SUBJECT: Comanche Peak Nuclear Power Plant, Docket Nos. 50-445 AND 50-446,
Fourth Six-Month Status Report in Response to March 12, 2012, Commission Order
Modifying Licenses with Regard to Requirements For Mitigation Strategies For Beyond-
Design-Basis External Events (Order Number EA-12-049) (TAC NOS. MF0860 and
MF0861)

**Comanche Peak Nuclear Power Plant's (CPNPP) Fourth Six Month Status Report
for the Implementation of Order EA-12-049, Order Modifying Licenses with Regard to
Requirements for Mitigation Strategies for Beyond-Design-Basis External Events**

Figure A3-23: Phase 2 480VAC FLEX Generator Connection to Plant Support Power
103

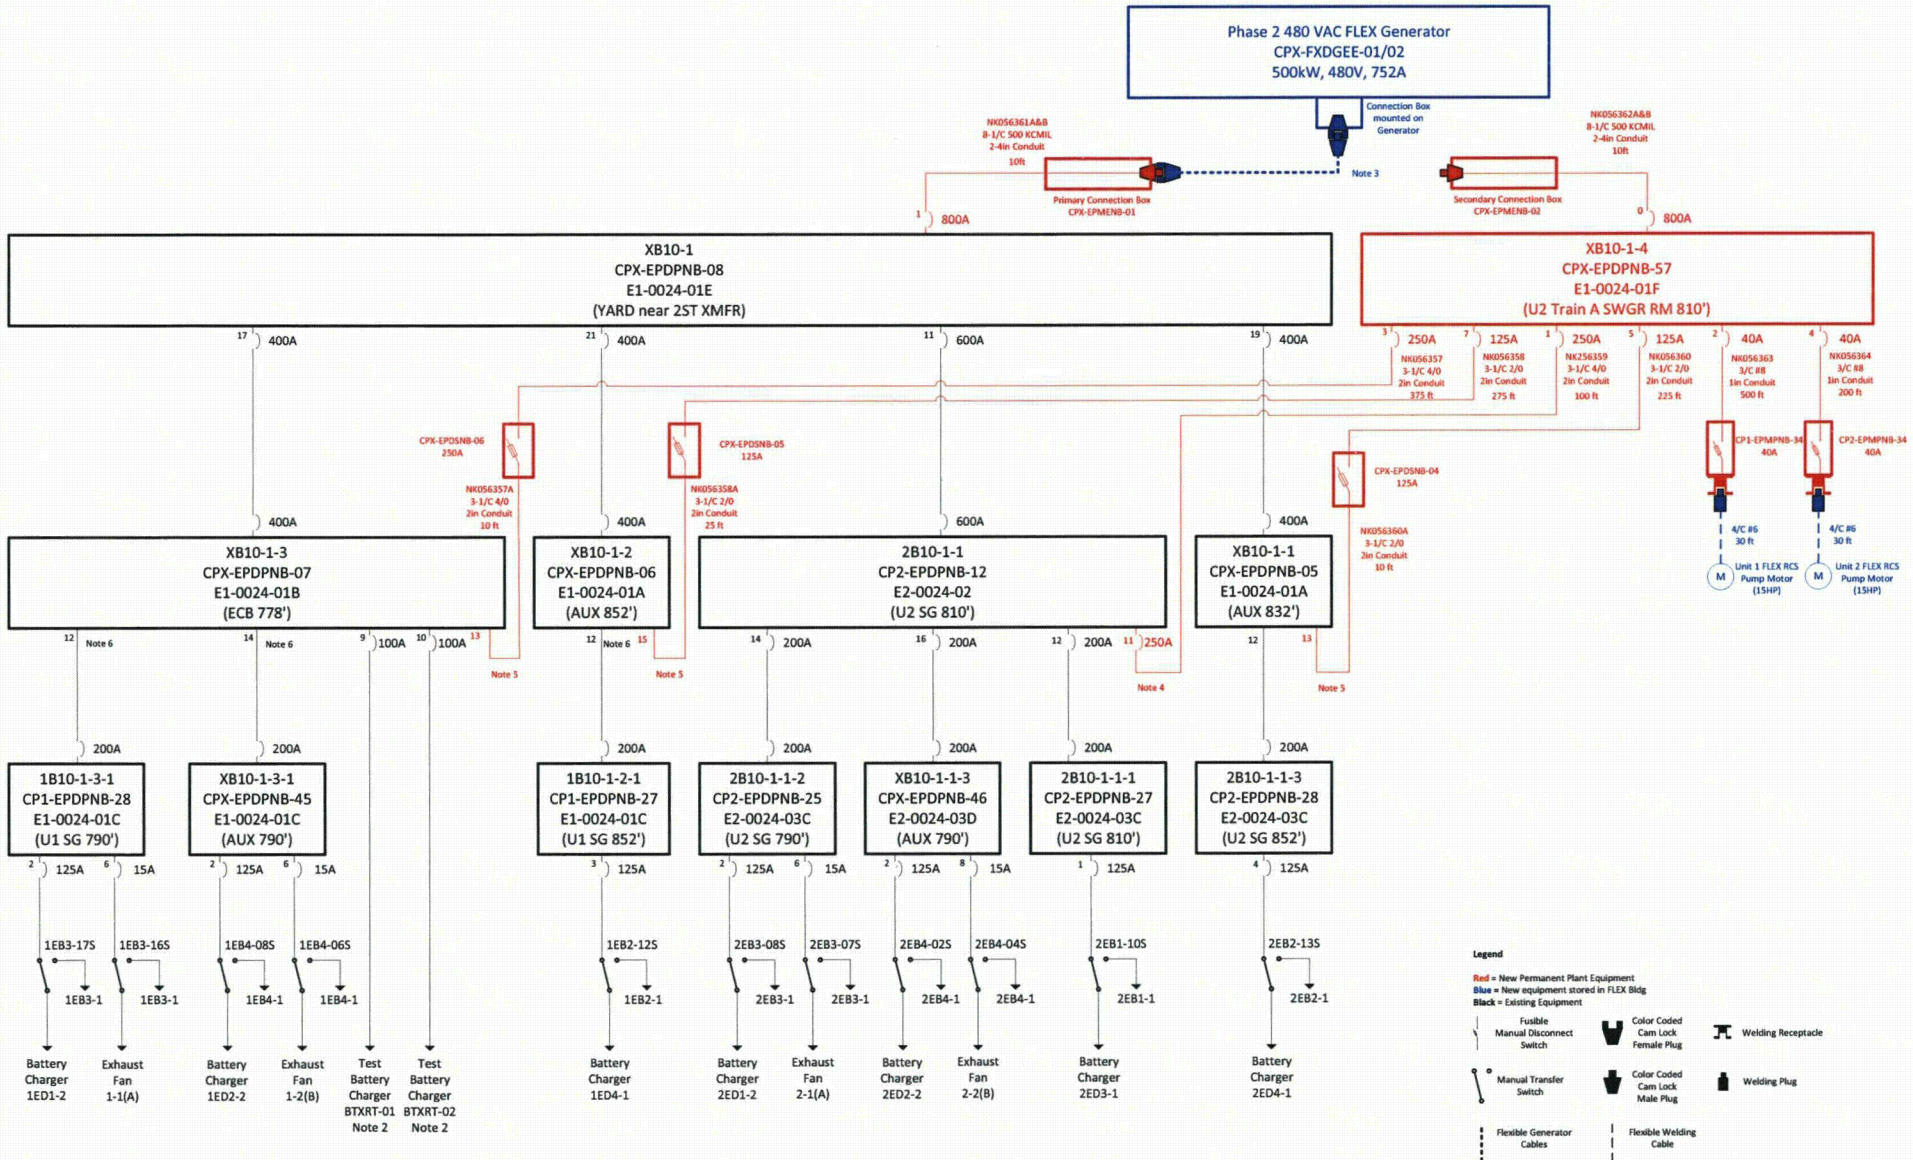
Phase 2 480V Generator Connection to Plant Support Power

Further review of Figures A3-23 through A3-29 of the OIP concludes improvement in understanding of the associated Phase 2 FLEX strategy can be achieved by figure consolidation. This is not a change in compliance method but merely an improvement in the depiction of the Phase 2 480VAC generator and its physical connection to the credited Phase 2 loads through Plant Support Power. Figure A3-23 of the OIP should be replaced with that provided in Appendix A of this letter and Figures A3-24 through A3-29 of the OIP should be deleted. All text references in the OIP to Figures A3-24 through A3-29 should reference Figure A3-23 solely.
